**EDINBURGH TRAM YORK PLACE TO NEWHAVEN  
STAGE 3 ROAD SAFETY AUDIT RESPONSE REPORT**

PROJECT			ORIGIN			VOLUME			LEVEL		TYPE		ROLE		NUMBER				REV		
E	T	Y	N	S	E	F	X	X	X	0	3	R	P	D	0	0	9	2	P	0	1

November 2023

Figure 1 - Cycle Crossing at Newhaven

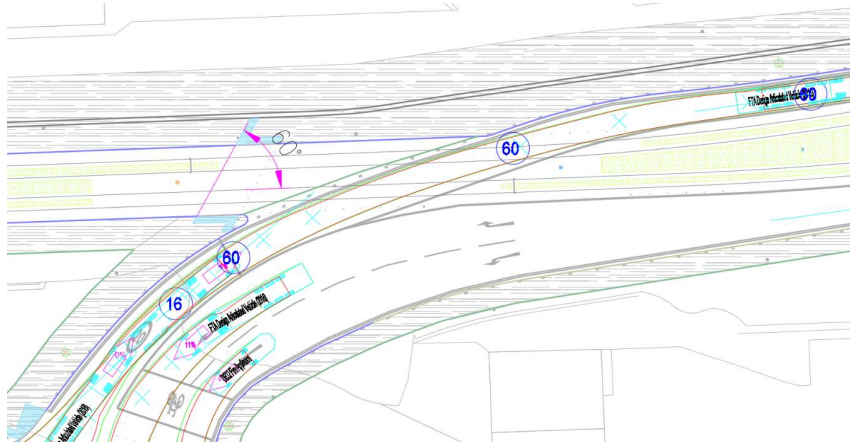
The Audit Team note the Designer’s response comments, however there are still locations where cyclists can choose to travel and where there is a risk that they could cross the tram tracks at a very shallow angle and lose control as a result of a wheel entering the tram track. The above photo shows an example of this on Melrose Drive. The Audit Team retains the above recommendations.

Throughout the scheme extents the design team have assessed the cycle crossings and confirm at no point do the cycle ways or cycle lanes, where provided, cross at an angle below 60 deg as per Figure 1.

Figure 2 - Ocean Drive Road Markings

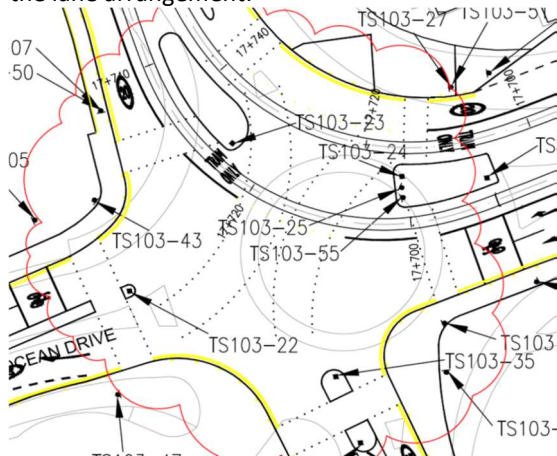
The drivers / riders of vehicles turning onto Ocean Drive, particularly those from Victoria Quay, could inadvertently enter the tram lane and make a lane change upon realising that they are in the wrong lane, leading to side-swipe collisions occurring with vehicles in the nearside lane.

The Audit Team retain their belief that this is an issue. The drivers / riders of vehicles turning onto Ocean Drive, particularly those from Victoria Quay, could inadvertently enter the tram lane and make a lane change upon realising that they are in the wrong lane, leading to side-swipe collisions occurring with vehicles in the nearside lane. It should be noted that during the site investigation the road markings through the junction had not been provided.

The provision of road markings through the junction will assist to guide vehicles from Victoria Quay into the correct lane. 'Tram Only' road markings have also been provided to make drivers aware of the lane arrangement.
